FACILITY: San Onofre Nuclear Generating Station, Unit Nos. 2 and 3  
LICENSEE: Southern California Edison Company (SCE)  
SUBJECT: SUMMARY OF MEETING HELD ON DECEMBER 7, 1988  
RE: SPENT FUEL POOL RERACKING

## SPENT FUEL POOL RERACKING MEETING

Issues to be Addressed in the License Amendment Request

# EFFECTIVE STRUCTURAL PROPERTIES

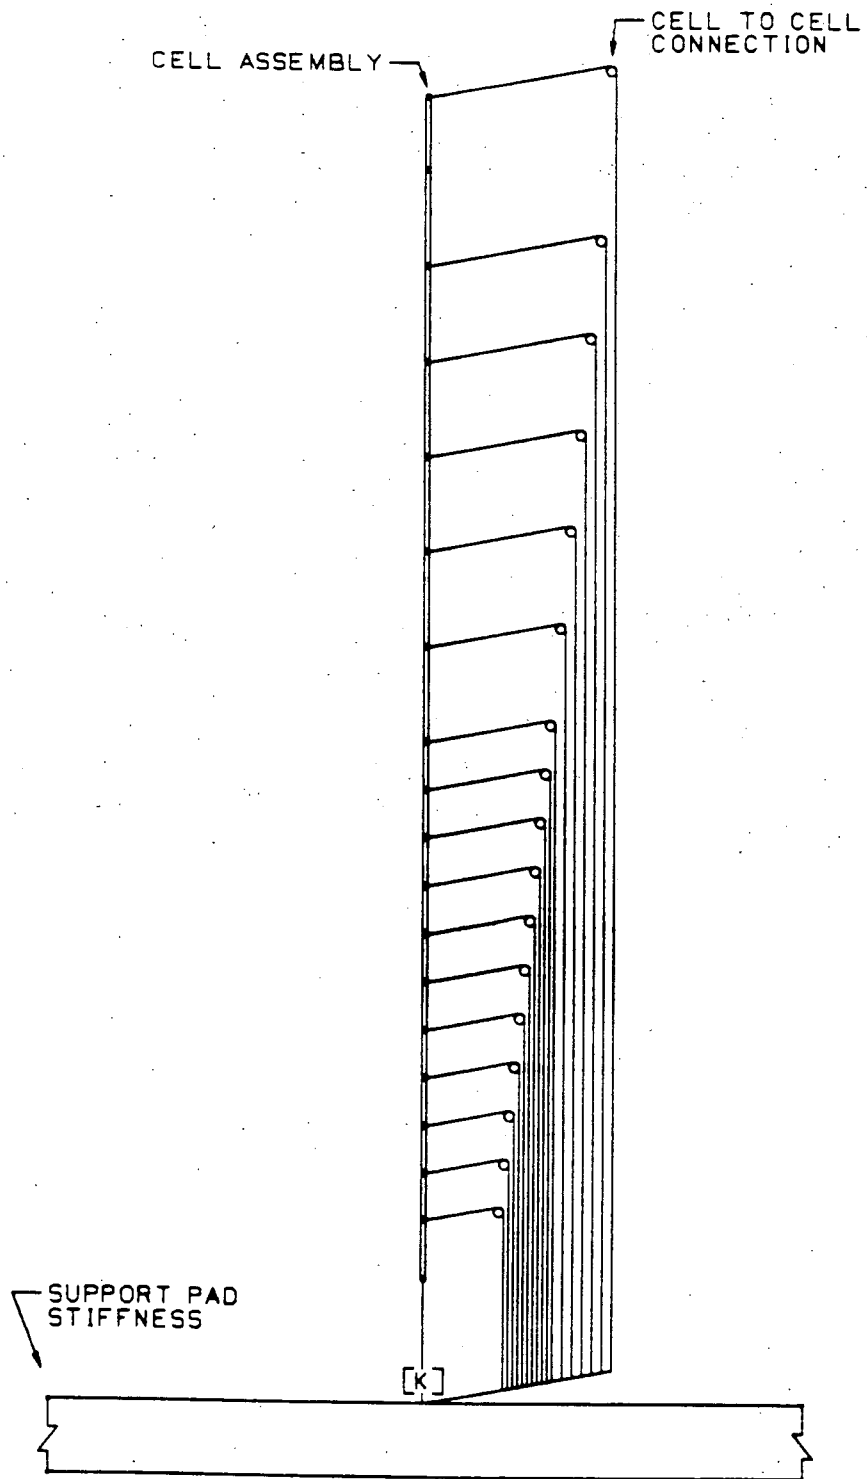
- B. Analysis method and calculation to determine the effective rotational stiffness properties of the cell-to-cell connections for the effective structural model.

- C. Analysis method and calculation to determine the effective rotational stiffness properties of the fuel rack base for the effective structural model.

# MULTIPLE RACK POOL MODEL

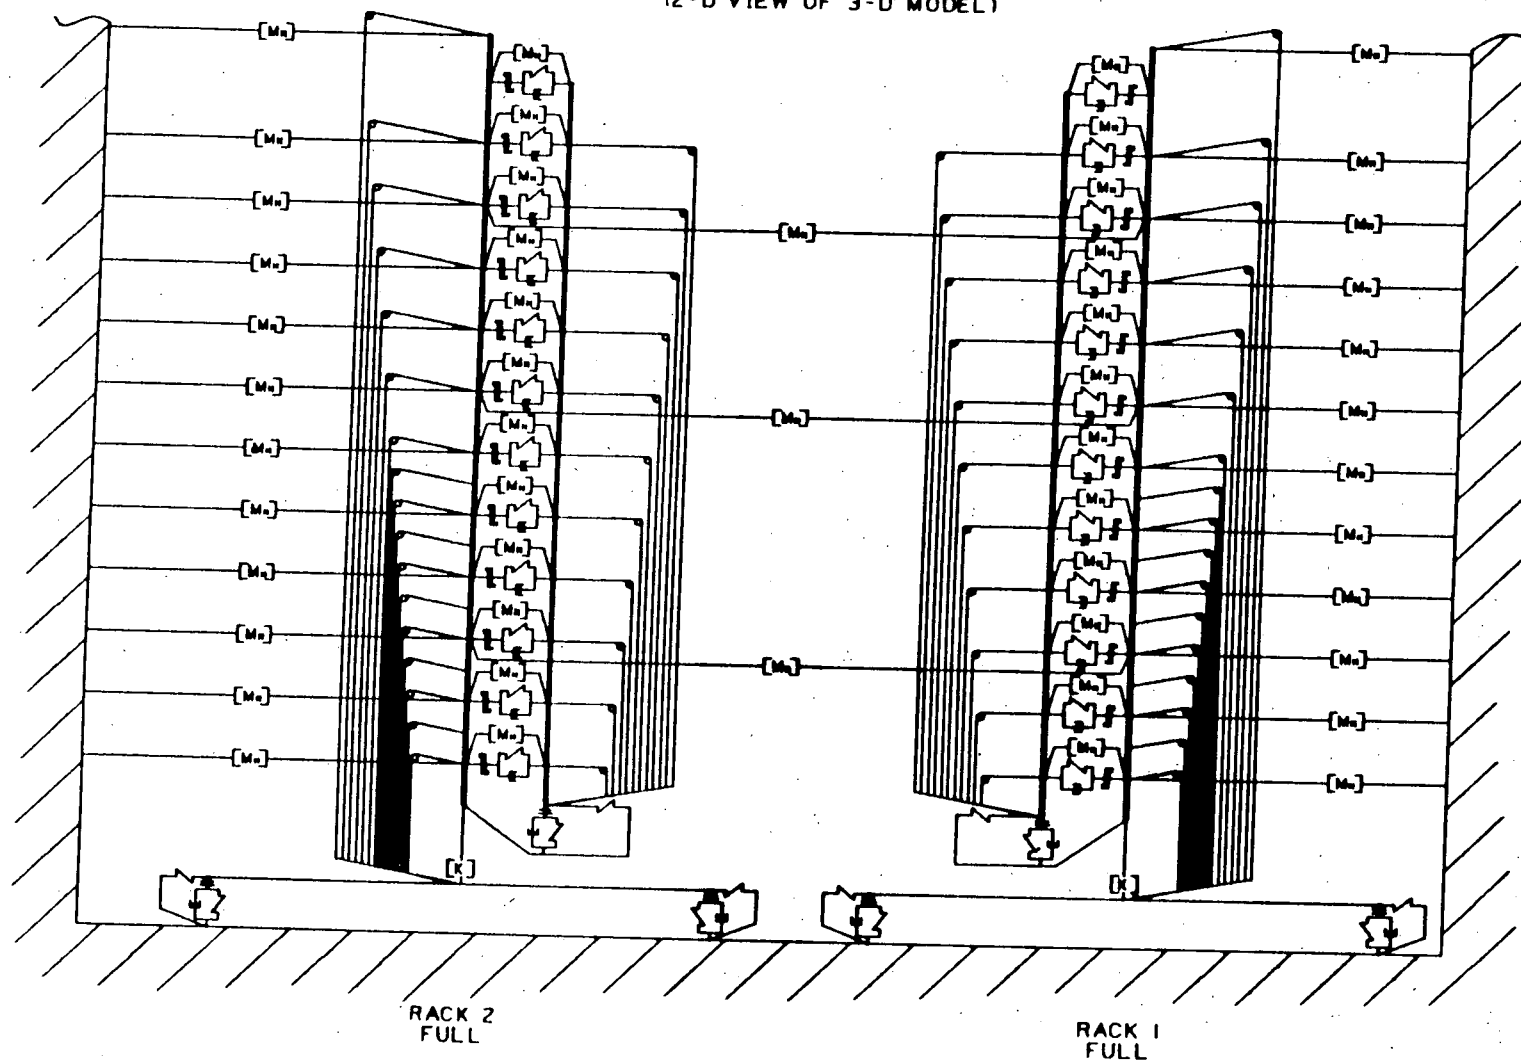
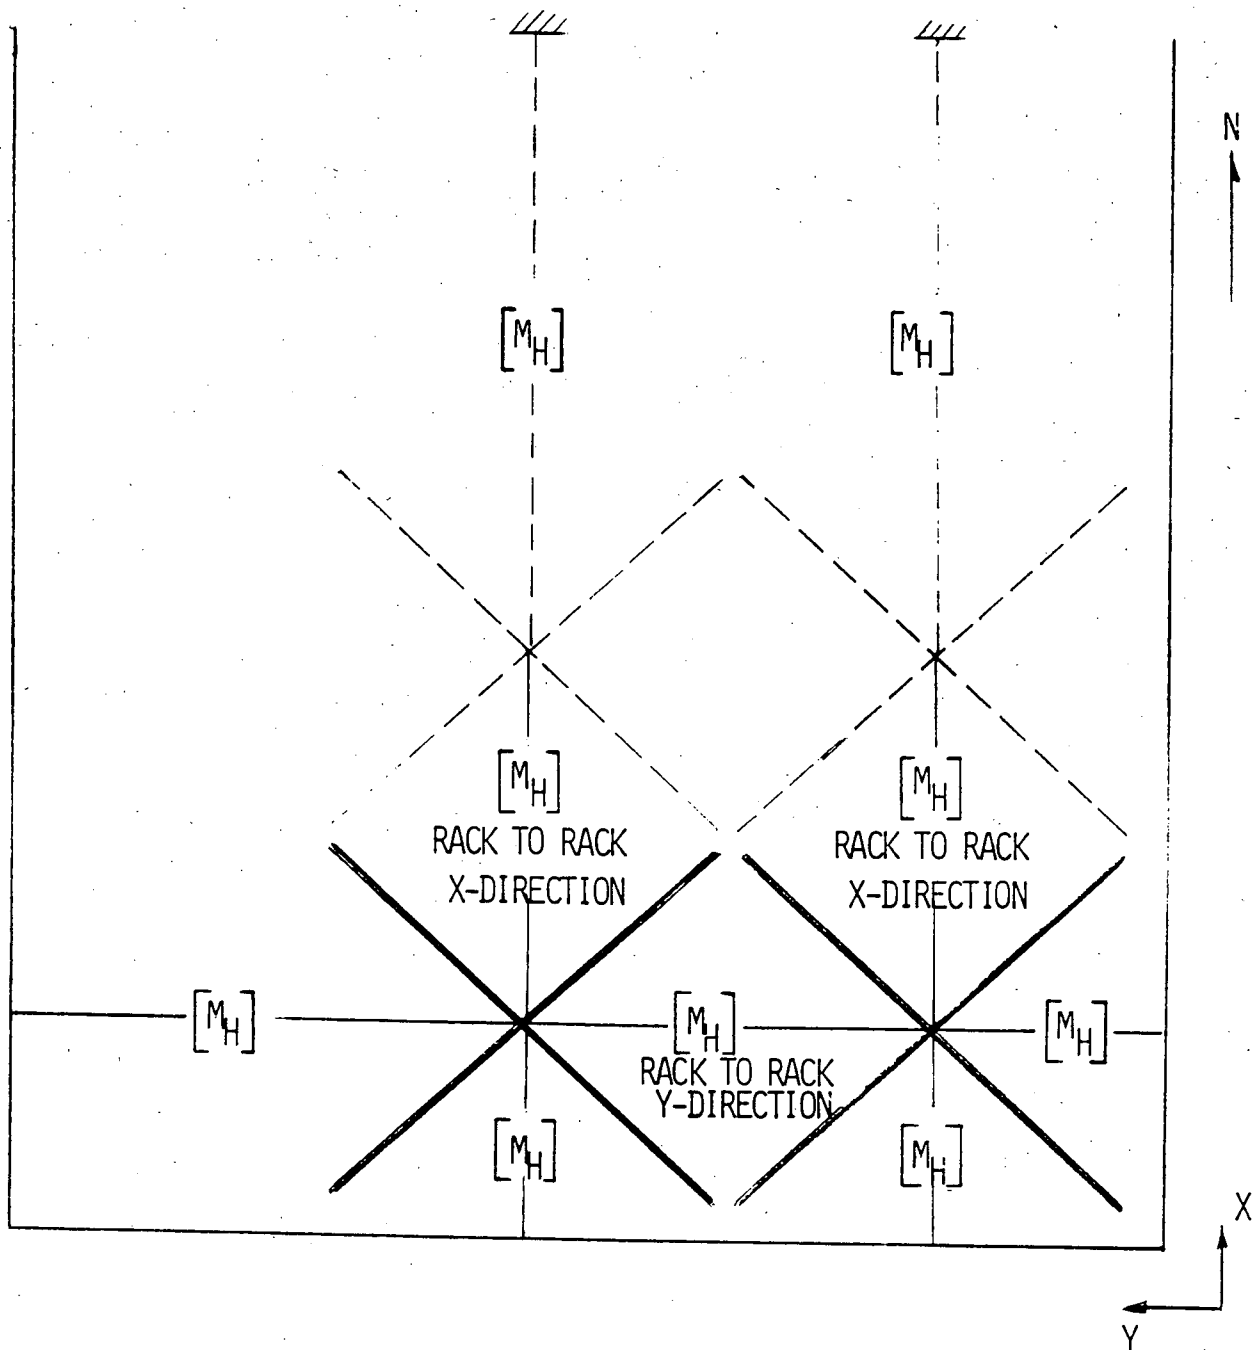
- B. Justification of the hydrodynamic mass simulation in the N-S direction (4 rack configuration).
3. Maximum support pad lift-off and margin against overturn.
